Value Engineering Study

Final Report

VE Number: 202303

I-75 Widening, MP 20.2 to MP 28.851 Laurel & Whitley Counties

SUPERELEVATED SECTION
STA. 1276+00 TO P.T. STA. 1288+69.55

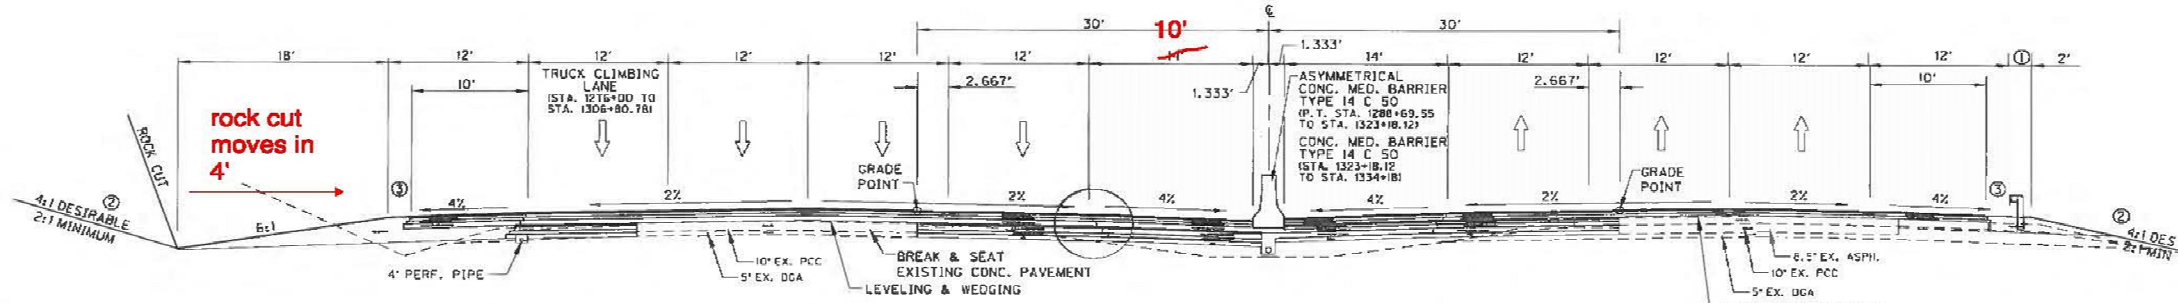
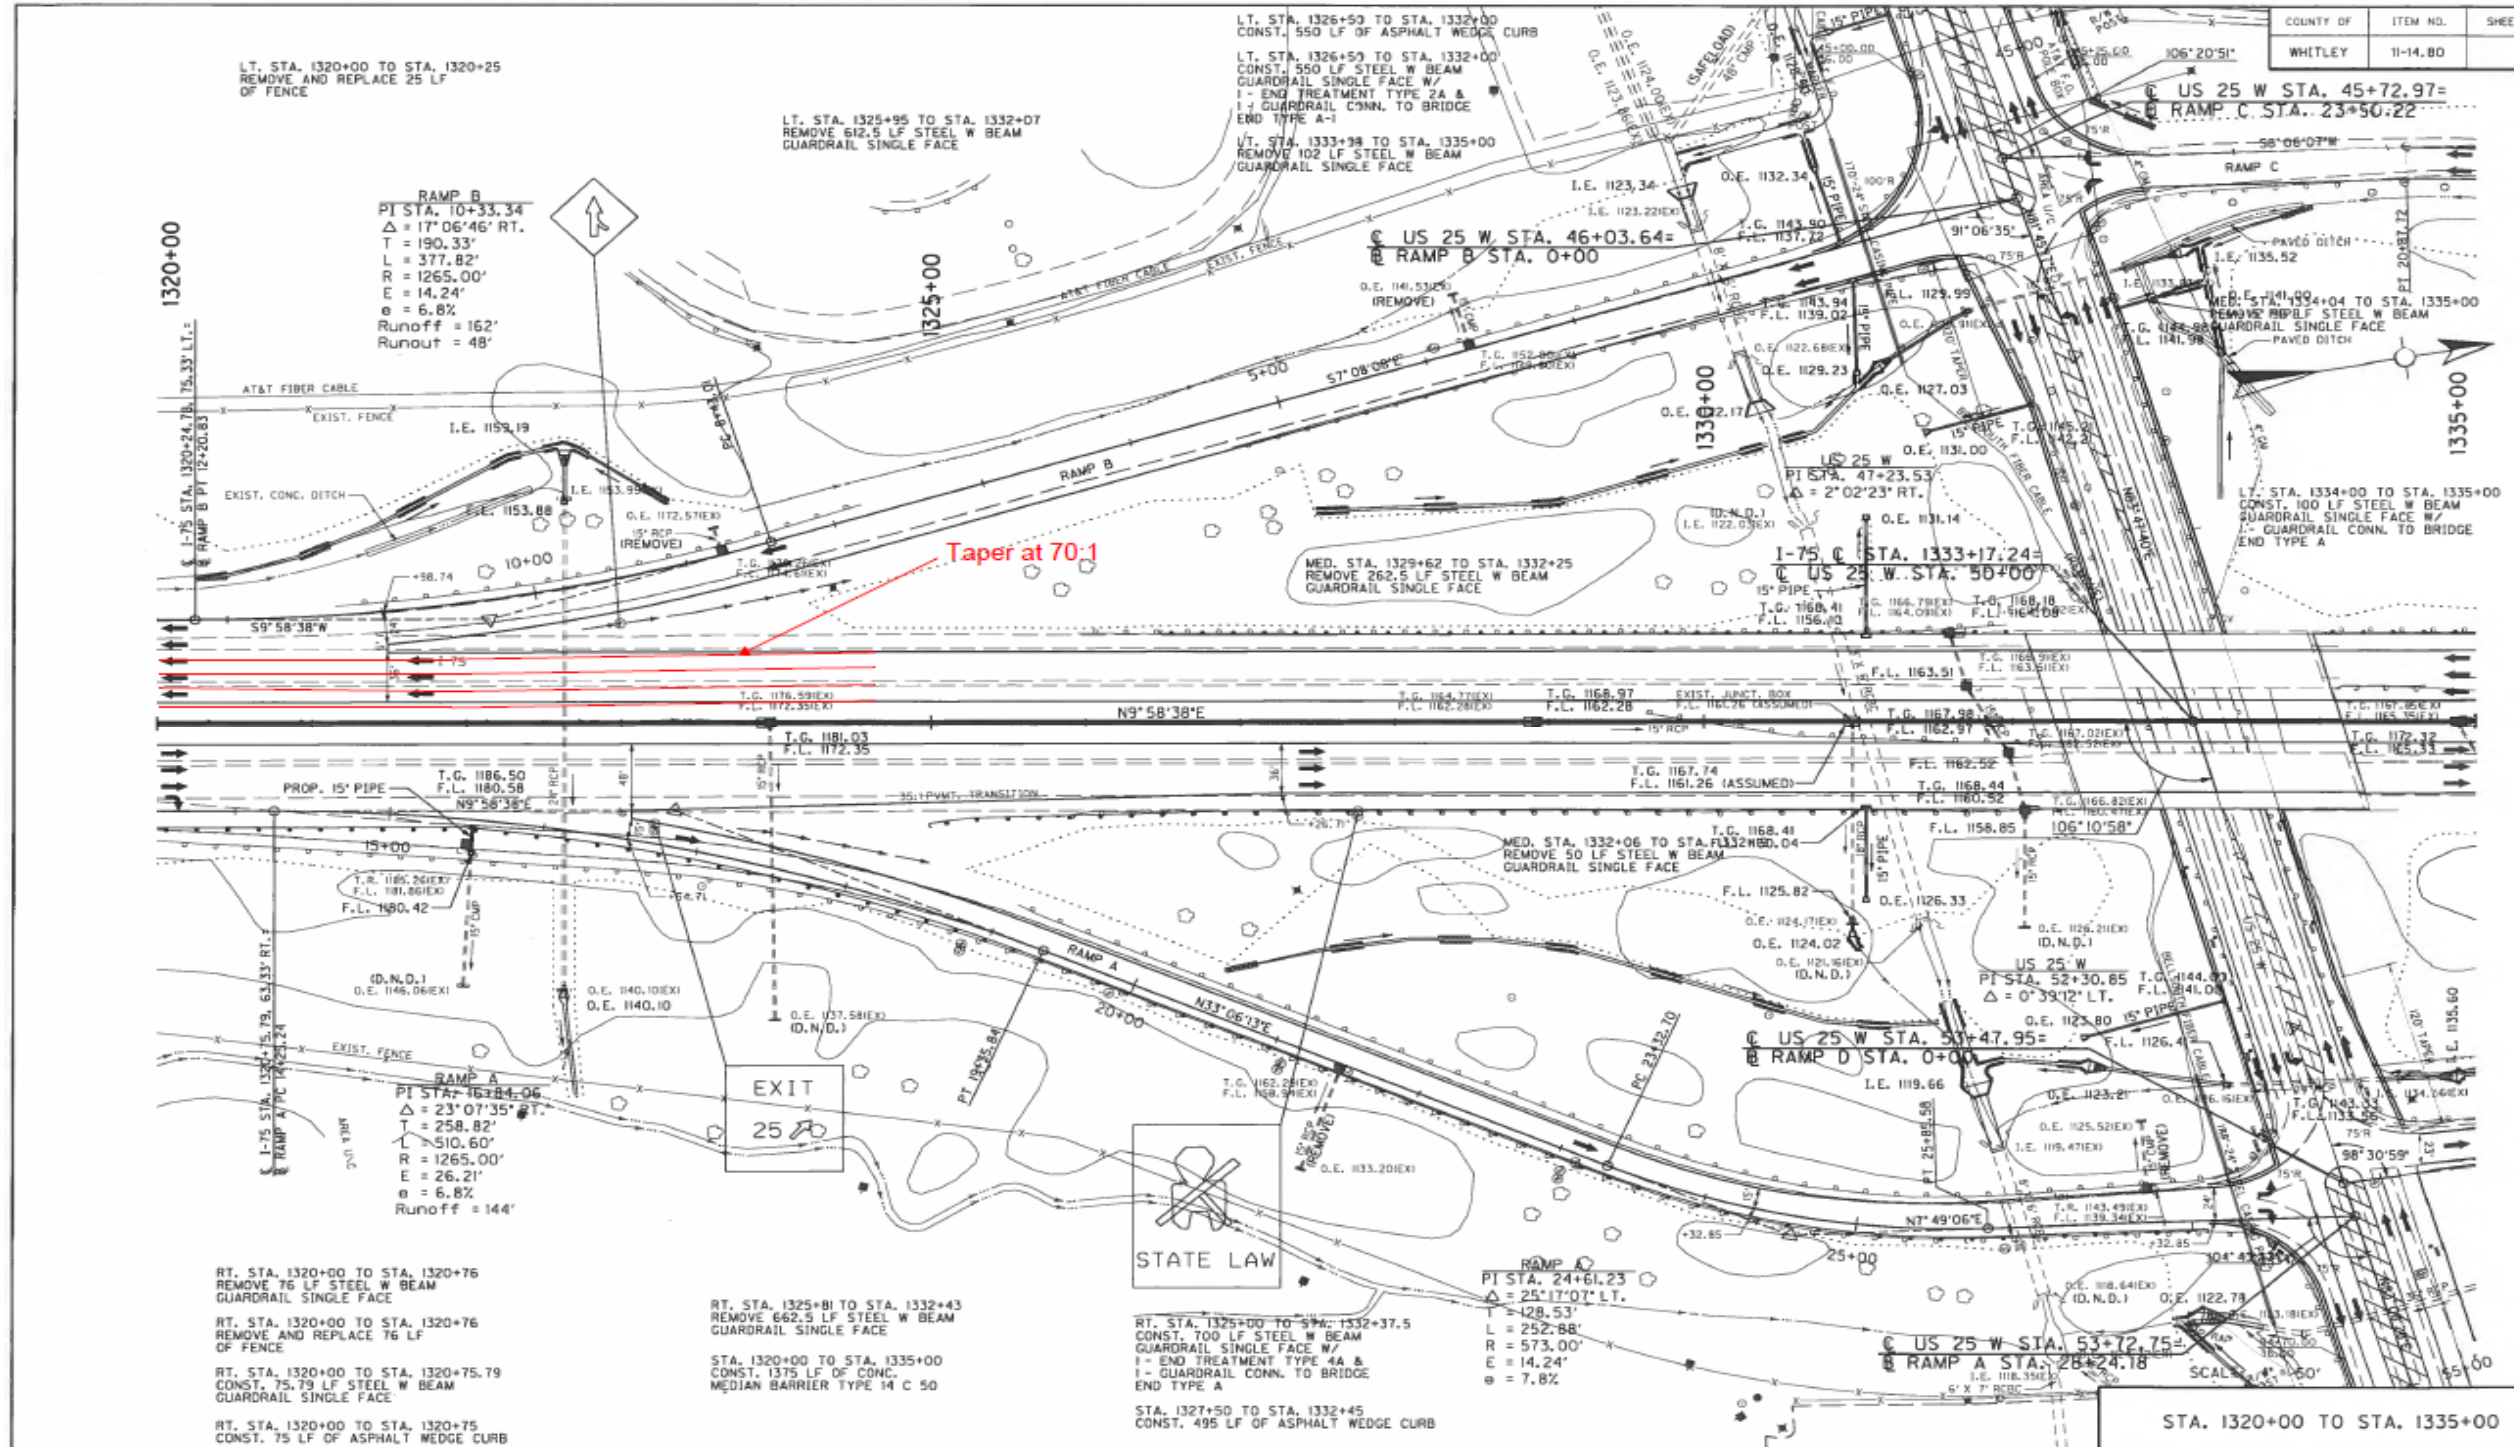
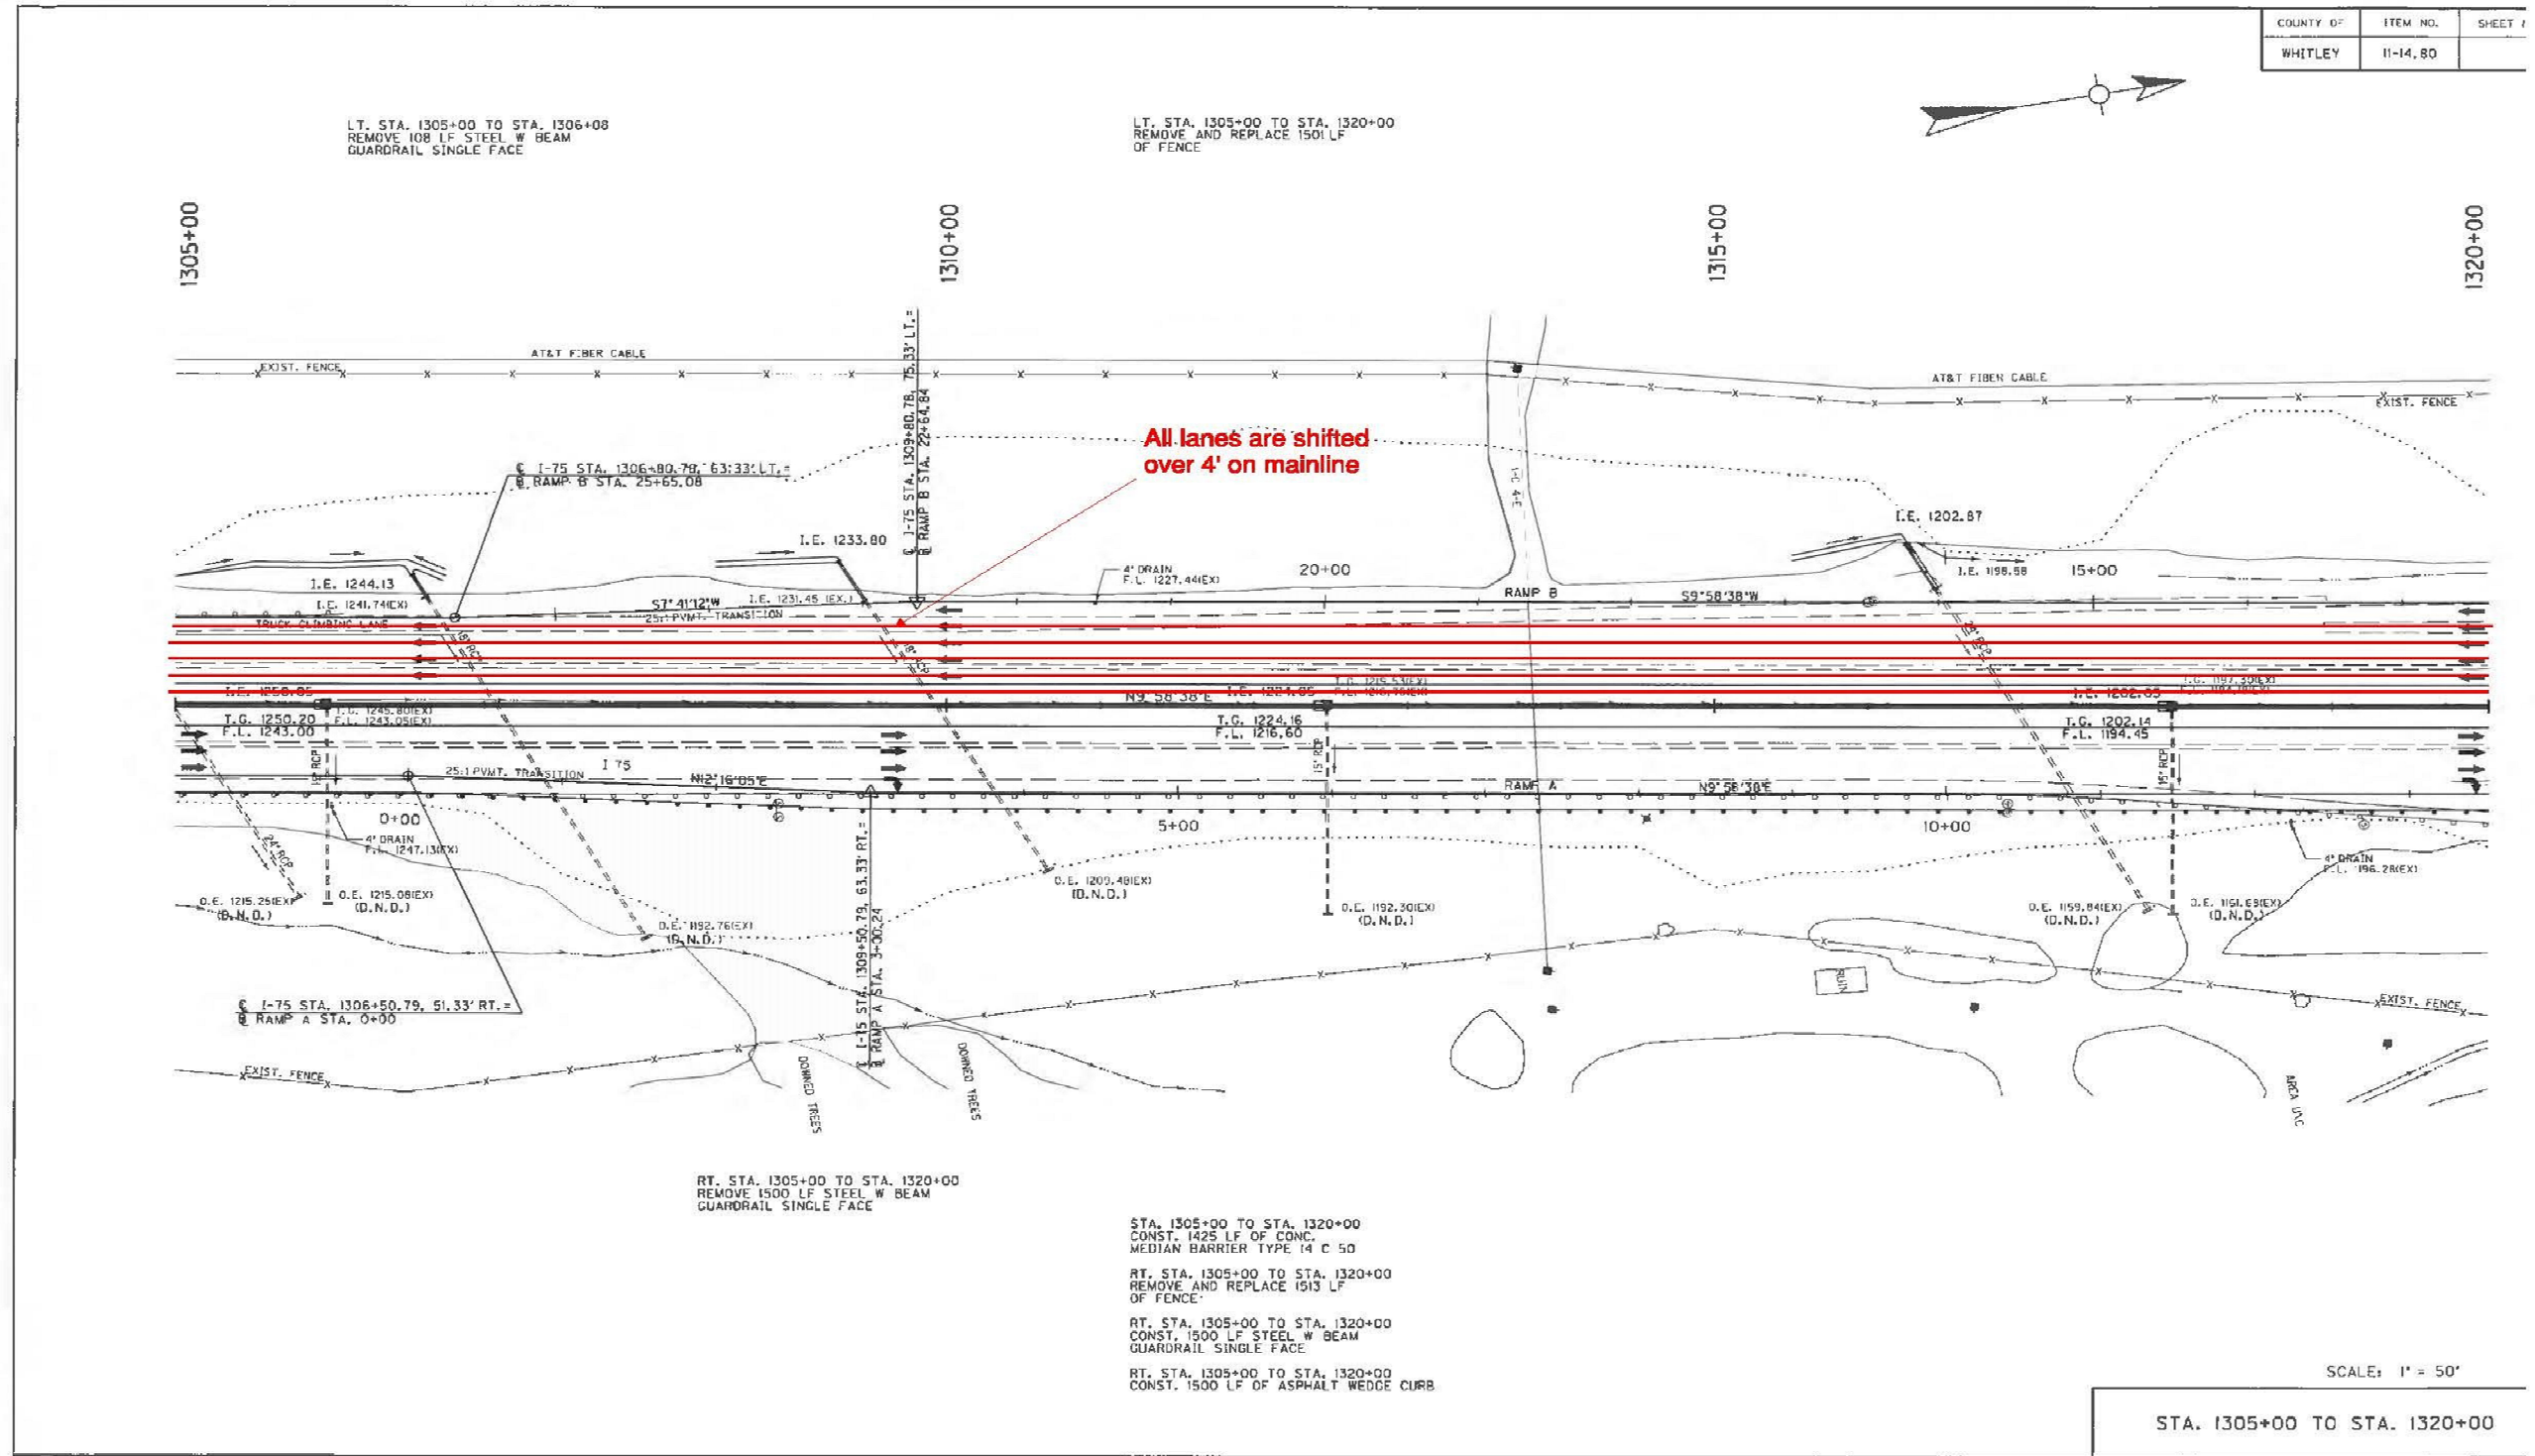
TITLE	At the truck climbing lane, use a 10' shoulder on the outside and an 8' shoulder on the inside to provide improved pull-off area on the outside shoulder, avoid rock cut, and provide for appropriately shaped truck climbing lane				
VALUE PROPOSAL SYNOPSIS:					
Avoidance of rock cut in the area of the truck climbing lane in order to maintain the truck climbing lane beyond the crest as required by federal standards for safety.					
 Reliability	Maintained	 Functionality	Maintained	\$ Initial Cost Avoidance (Add) \$941,000	
 O&M	Improved	 Schedule Impact	Improved		
BASELINE CONCEPT:					
The current configuration would maintain the truck climbing lane to the safe point, but would result in excessive rock cut on the outside shoulder.					
VALUE PROPOSAL DESCRIPTION:					
The value proposal would allow all federal guidance to be followed for shoulder widths and length of lane while greatly reducing or eliminating the need for rock cut on the outside southbound shoulder.

TITLE	At the truck climbing lane, use a 10' shoulder on the outside and an 8' shoulder on the inside to provide improved pull-off area on the outside shoulder, avoid rock cut, and provide for appropriately shaped truck climbing lane
DISCUSSION & JUSTIFICATION:	
<p>I-75 southbound near the exit 25 entrance ramp is on a steep grade uphill along the main corridors. Couple that the fact that US 25W crosses under I-75, trucks entering southbound I-75 from exit 25 have a lengthy and steep path to try and get up to speed before entering I-75. Ending the truck climbing lane prior to the crest can leave trucks merging into 70 mph traffic at a less than needed speed causing a severe safety issue. However, this area just south of the exit consists of substantial rock cut. The rock in this cut does not appear to be of good quality and removal of any rock could propagate further into the cut section.</p>

17

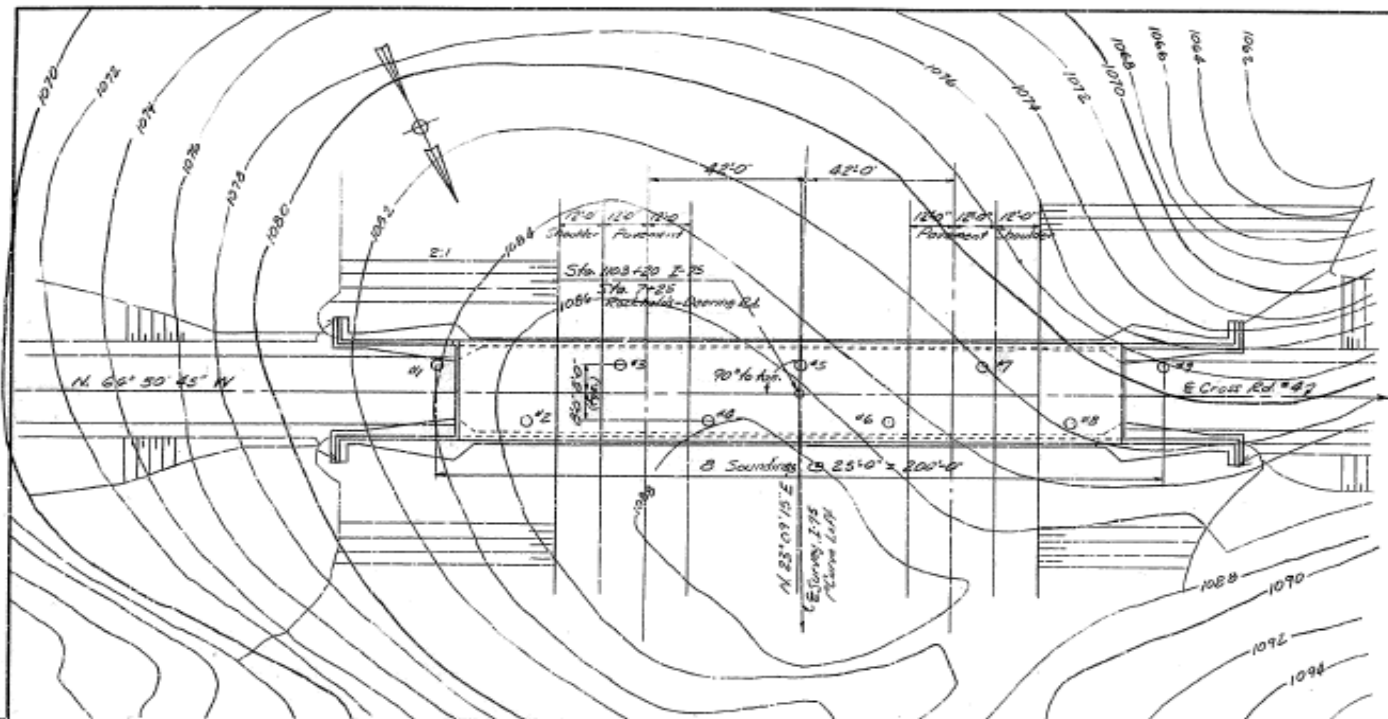
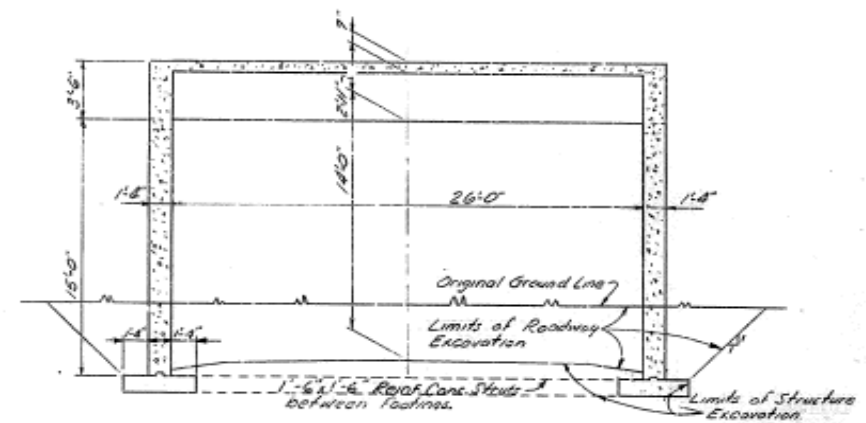
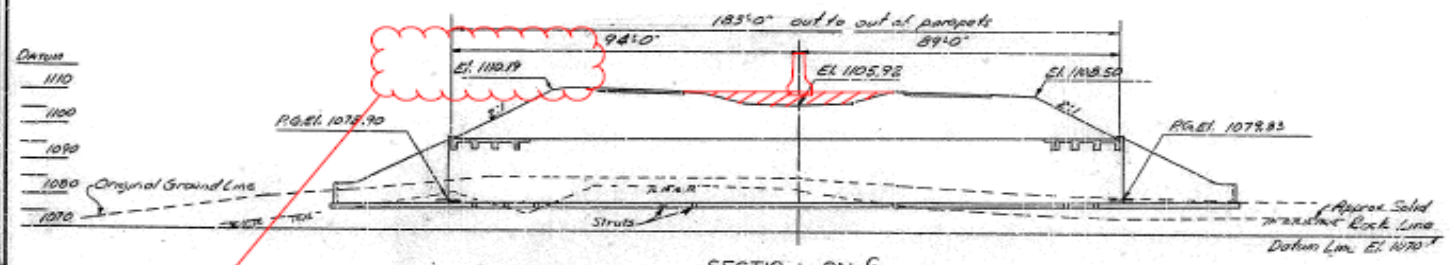
TITLE	Over Tidal Wave Road bridge, avoid increasing total (max) fill while widening in order to avoid the need to rebuild the bridge		
VALUE PROPOSAL SYNOPSIS:			
Tidal Wave Road is one of a couple culverts under I-75 within the project area. These culverts, if determined structurally sound, should be left in place under current loading design. The design should incorporate no additional fill overtop the culvert, staying within the max fill criteria.			
 Reliability	Maintained	 Functionality	Maintained
 O&M	Maintained	 Schedule Impact	Improved
			\$ Initial Cost Avoidance (Add)
			\$926,000
BASELINE CONCEPT:			
The baseline concept as explained would bring the existing culverts up to current ratings code. This would require either strengthening or replacement with a new structure.			
VALUE PROPOSAL DESCRIPTION:			
The value team proposes adding no additional fill beyond the max fill limit with the current culverts remaining in place for continued use.

TITLE	Over Tidal Wave Road bridge, avoid increasing total (max) fill while widening in order to avoid the need to rebuild the bridge
DISCUSSION & JUSTIFICATION:	
<p>The information provided led the project team to believe that strengthening or replacement of the existing culverts would need to take place in order to meet loadings. It was stated that all widening would occur to the inside of the roadway. If outside slopes are left as currently designed, there would be substantial benefit in simply leaving the culverts in place as they are and using them with the current HS20 load specifications.</p> <p>Assuming the culverts are designed to the max fill height across the entire culvert length, filling the median to this elevation likely will not cause issue. In super elevated sections, however, the road may need to be lowered slightly to account for the additional weight due to the super.</p> <p>In addition, in lieu of placing an additional 2 lifts of base and surface on the structure, this may need to be milled down. Accounting for a 1"=100' transition of mainline existing pavement, we would need to mill down 7.75" so as not to raise the existing profile at the culvert. This transition would take 1550' approximately to drop down and raise back up.</p>
